**TECHNICAL BULLETIN**
**[ 1 / 4 ]**

[Issue No.] GOT-A-0071-B

[Title] GT16 models parts change (LCD, buzzer, and reset switch)

[Relevant Models] GOT1000 Series

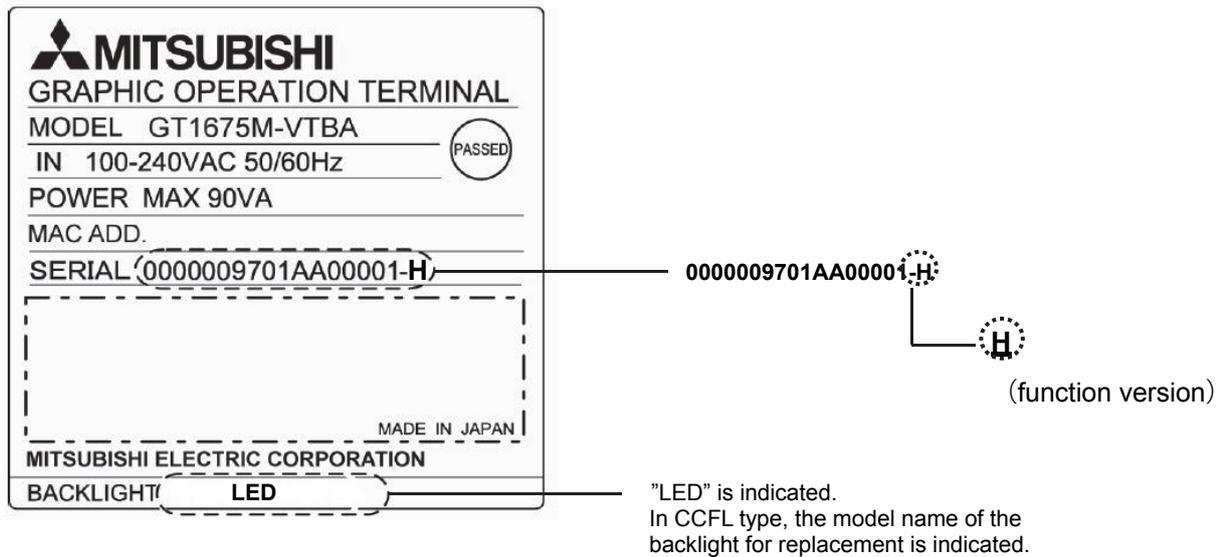
Product	Model	Buzzer	Reset switch
GOT	GT1695M-XTBA	(1)Details of change: The sound slightly changes.  (2)Reason for change: The parts are now obsolete or hard to obtain.	(1)Details of change: The color of reset switch is changed from Brown to Red  (2)Reason for change: ①Improvement of the operability ②For common use of parts
	GT1695M-XTBD		
	GT1685M-STBA		
	GT1685M-STBD		
	GT1675M-STBA		
	GT1675M-STBD		
	GT1675M-VTBA		
	GT1675M-VTBD		
	GT1675-VNBA		
	GT1675-VNBD		
	GT1672-VNBA		
	GT1672-VNBD		
	GT1665M-STBA		
	GT1665M-STBD		
	GT1665M-VTBA		
	GT1665M-VTBD		
GT1662-VNBA			
GT1662-VNBD

■ Packaging box

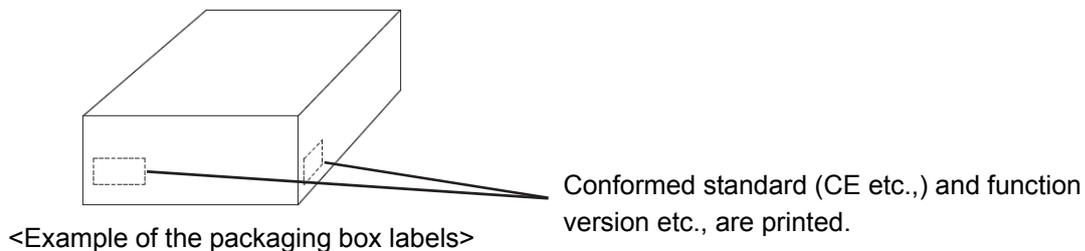
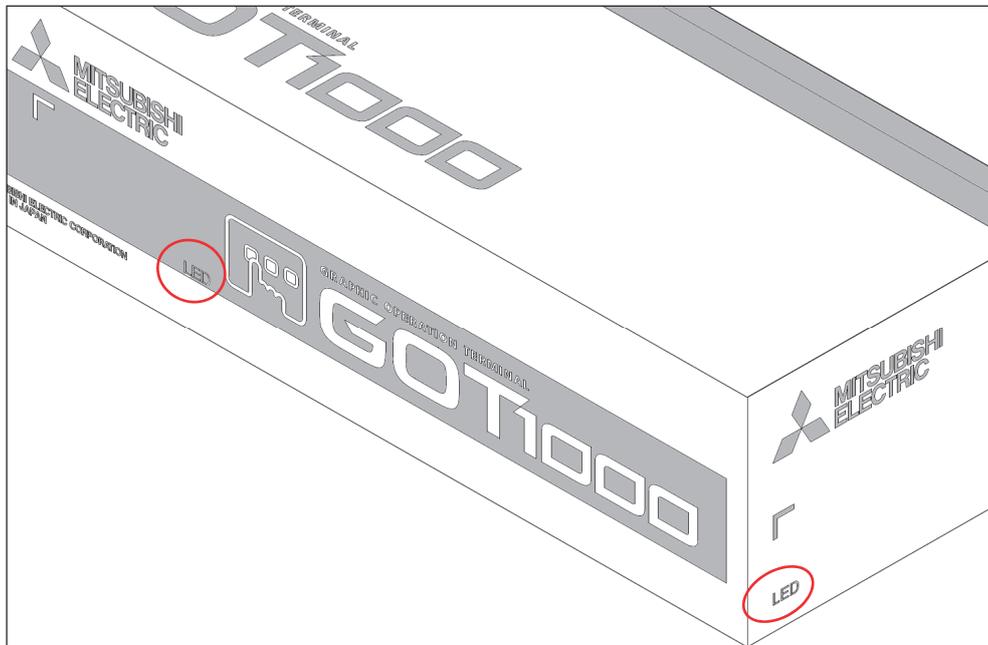
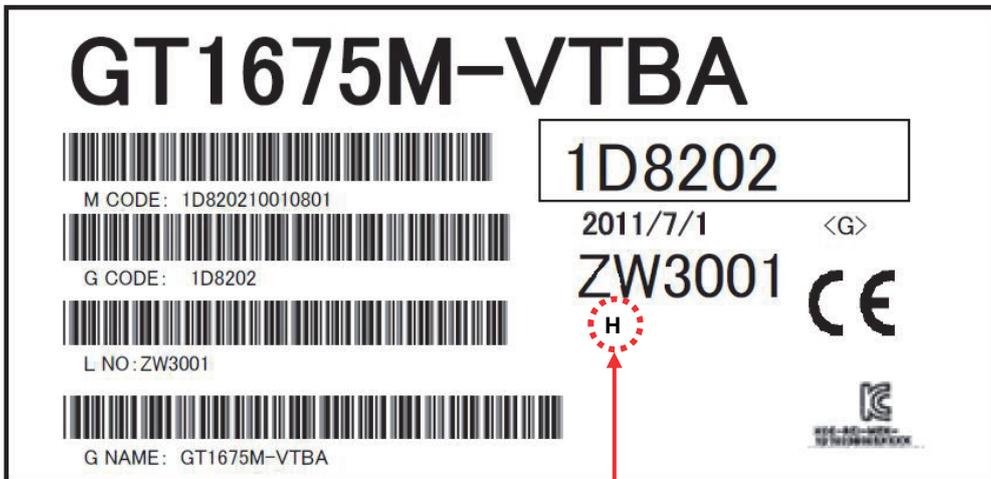
Confirm the version on the label and the print "LED" on the packaging box. The label position varies depending on the models or shipment time.

“LED” is printed on the target model’s package.
